CORRIGENDUM- 05

PROJECT	:	(3X200 MW+3x500 MW) RAMAGUNDAM STAGE-I & II FGD
PACKAGE	:	GYPSUM DEWATERING SYSTEM
TENDER ENQUIRY NO	:	PE/PG/RGM/E-6515/2020 Dt. 05/09/2020
SUBJECT	:	REGARDING REPLY OF PRE BID QUERY

PRE BID CLARIFICATIONS - 1

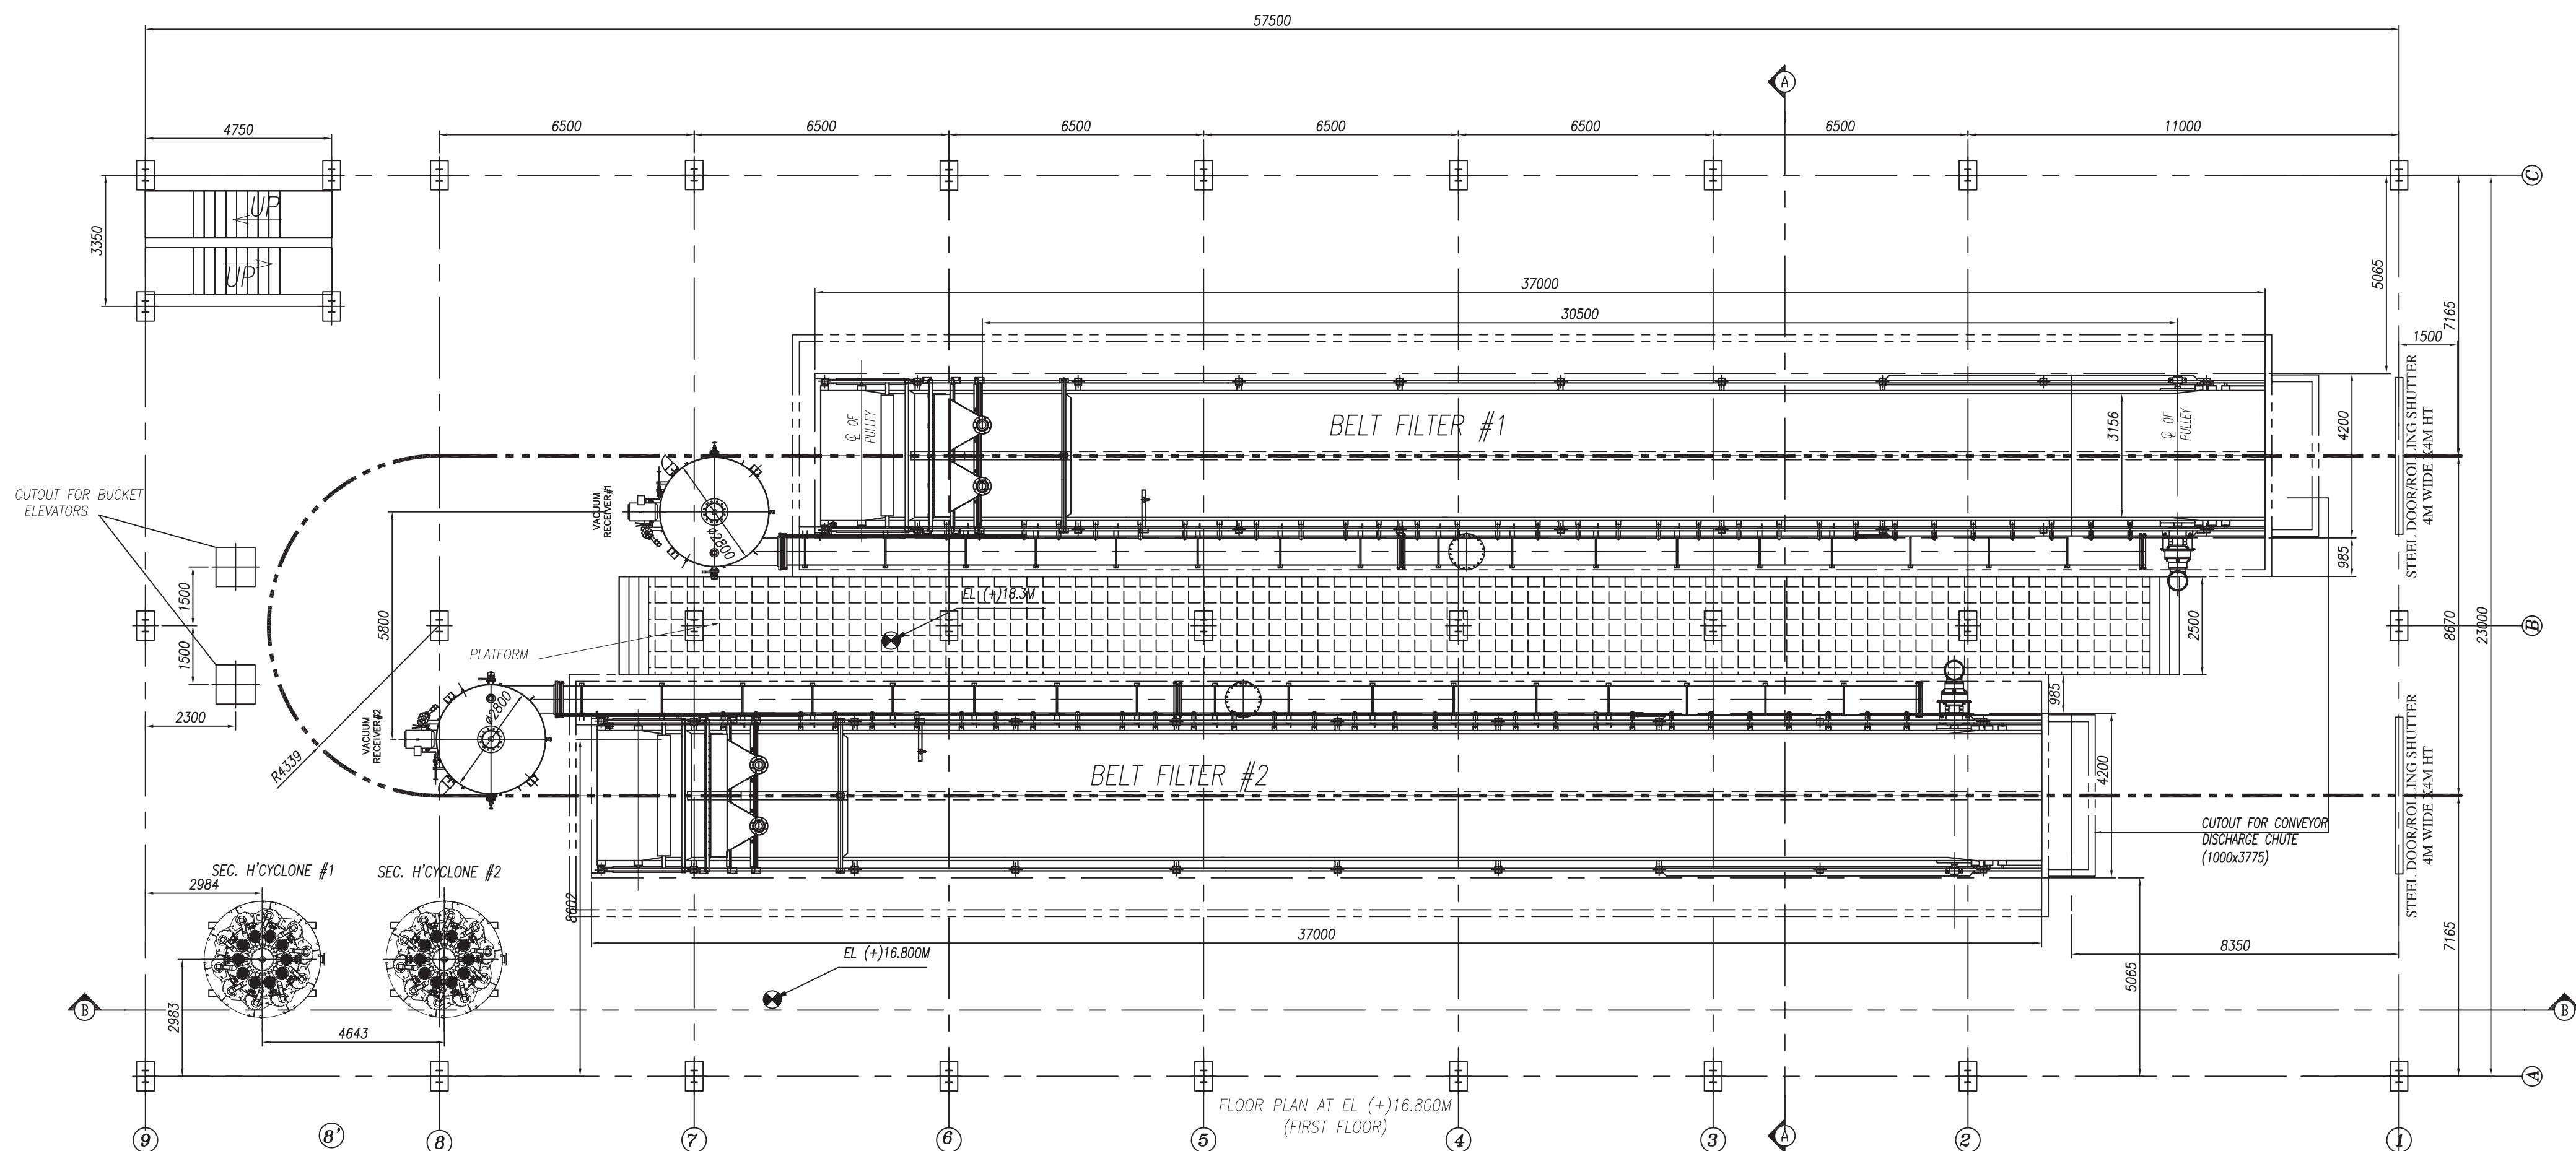
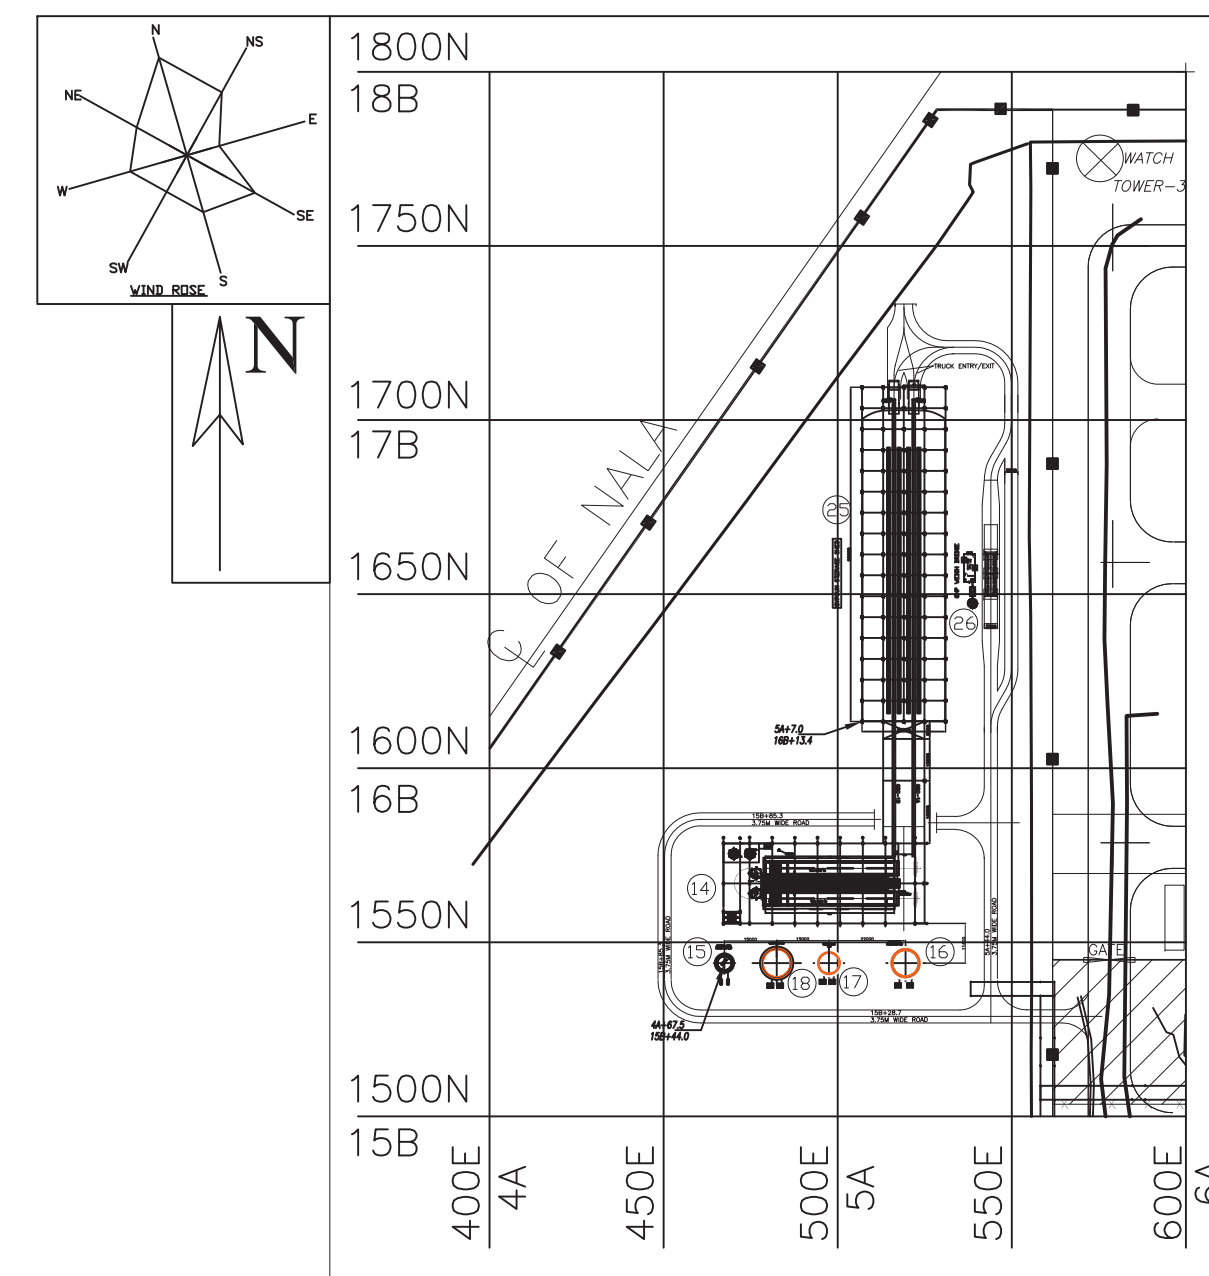
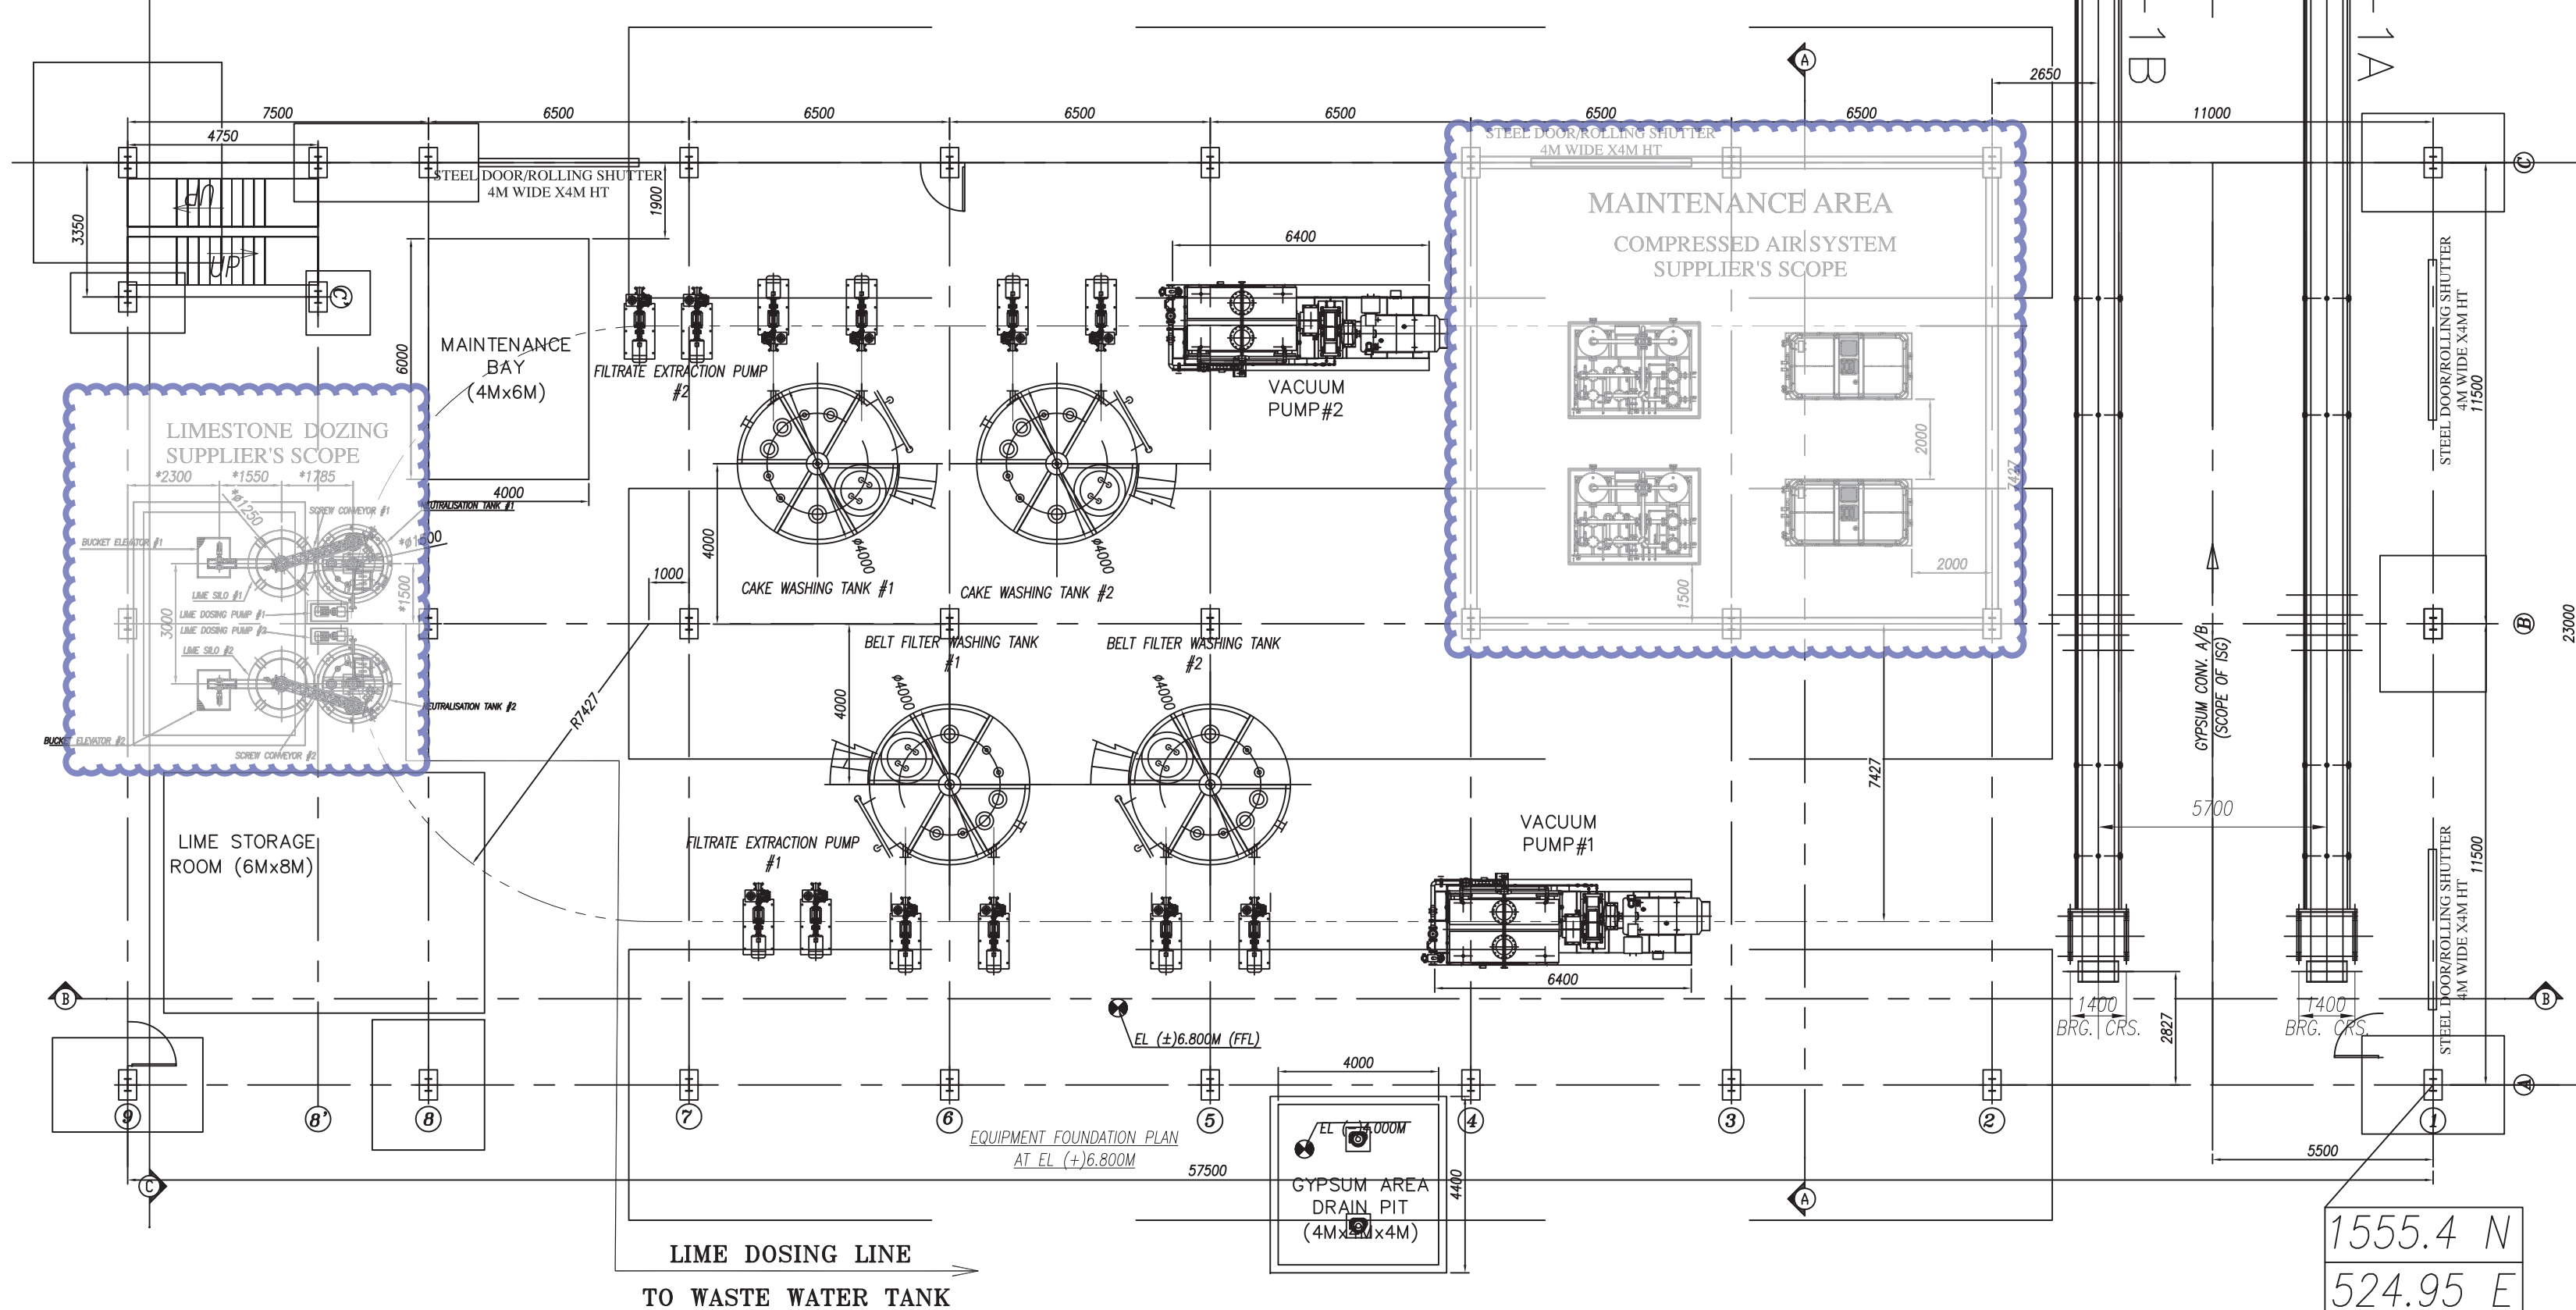
3	2.1.1.6	39 of 537	Vent fan including enclosure and its arrangement: Two (2) numbers	Bidder will consider Centrifugal type of vent fan. please confirm	Noted. Bidder to decide capacity and head of fan to meet system requirement in line with the tender specification.
4	2.1.1.6	39 of 537	Vent fan including enclosure and its arrangement: Two (2) numbers	Client to specify the MOC of Fume enclosure & ducting if any to be maintained.	Bidder to note that MOC of fan as well ducting shall be as per proven practice meeting the system requirement.
5	2.1.1.3	39 of 537	Vacuum belt filters complete with Accessories including discharge chute up to the gypsum conveyor skirt board.	Belt width & skirt board inside dimension to be provided to check the feasibility of proposed arrangement & profile of chute & angle.	Bidder to refer "Layout details of Gypsum Dewatering Building" page 412 & 413 of 537. The width of Gypsum conveyor belt is 800 mm and that of the skirt board is 533 mm. Revised "Layout details of Gypsum Dewatering Building" Rev 01 is also attached as Annexure-A to this pre-bid clarifications..

Hence, request you to kindly confirm whether we can quote considering the above mentioned MOC, or should we consider SS 304 for Filter considering the clause 4.3.4.	
11	4.3.10	47 of 537	The filtrate from gypsum slurry and from cake washing shall be taken to a separate vacuum receiver tank(s) as per the proven practice of the supplier. Each belt filter shall have an independent vacuum pump.	Filtrate from slurry and cake washing will be collected in the single receiver, this is the proven practice hence Separate receiver tank is not required (as per Client PID dwg no : 3-FW-000-01095 filtrate is collecting in single receiver).	The P & ID attached with tender specification has to be followed.
12	4.3.11	47 of 537	Gypsum cake from each belt filter shall be discharged through a hopper onto belt conveyor being provided by the Employer.	Bidder understand that hopper means discharge chute only, Gypsum cake from each belt filter shall be discharged through a chute arrangement instead of hopper onto belt conveyor indicated in GA drawing.	Bidder's understanding is correct. Further note that in "Layout details of Gypsum Dewatering Building" page 412 of 537 cut out for discharge chutes have already been indicated.

acceptable.		per Clause 4.3.12, Page 47 of 537 or it may provide a common platform of 3.3m (approx.) width. The "Layout details of Gypsum Dewatering Building" page 412 & 413 of 537 is for reference purpose. In case, common platform for HBF is provided as mentioned above, a movable platform along with access ladder shall be provided for approaching equipment/item on other side of HBF. A 1000 mm wide platform with suitable approach shall be provided by the bidder for each hydro cyclone as per Clause 4.5.36, Page 49 of 537.
25	4.5.34	49 of 537	Bidder to provide capacity of crane or hoist required for safe material handling and the details of heaviest component to be handled.	Details shall be provided during detail engineering. The handling facility for pumps in the layout shall be confirmed by Client to finalise the same.	Bidder's understanding is correct.
26	5.4	51 of 537	Hydro cyclone backpressure shall not exceed 20m H	Please clarify the requirement and Hydrocyclone feed inlet pressure will depends on the Hydrocyclone Vendor selection design to achieve the percent solids, Tonnage and PSD distribution.	Bidder to follow Tender specification.

42	1	271 of 537	LOCAL PANELS, This specification covers the Design, Manufacture, Inspection and Testing at the manufacturer's works, proper packing for transportation and delivery to site, supervision, erection, and commissioning at site of Local Panels required for control and monitoring of the Auxiliary Plant & Equipment.	Bidder will supply Junction boxes for the instruments, HBF can be controlled from client DDCMS.	Noted. However local control panel, if envisaged by bidder for their system operation, same shall be provided.
43	2.b	390 of 537	Mandatory spares list 2,b) Belt - 2 Sets	For spare belt - bidder shall supply wear belt or sealing belt	Bidder to note that a set shall mean complete replacement for one equipment. All type of belts shall be covered accordingly.
44		412 of 537	GA of GDWS	Please provide drawing in Acad version for FGD portion to workout the requirement & check the allocated space adequacy.	The "Layout details of Gypsum Dewatering Building" page 412 & 413 of 537 is for reference purpose. Same is to be finalized during detail engineering.

51				Drip tray (civil work) design, Engineering and supply is in Client scope.	Confirmed. However, bidder to provide the input of the drip tray during detail engineering.
52		412 of 537	Conveyor location	Please mark Centre line of conveyor w.r.t. to belt filter in GA drawing. BHEL to provide the conveyor details to finalise the profile of chute at conveyor feeding area (Skirt board inside width, length & height.)	Conveyor location is already indicated in the drawing attached with specification. However further details shall be provided during detailed engineering.
53			As per Layout drawing, Bucket Elevator, Lime feeding system, compressed air system marked in vendors scope	These scope of engineering and Supply is Excluded from Bidder scope, please confirm	These systems are excluded from the Gypsum Dewatering package and they are already marked under respective system supplier's scope in the layout drawing.
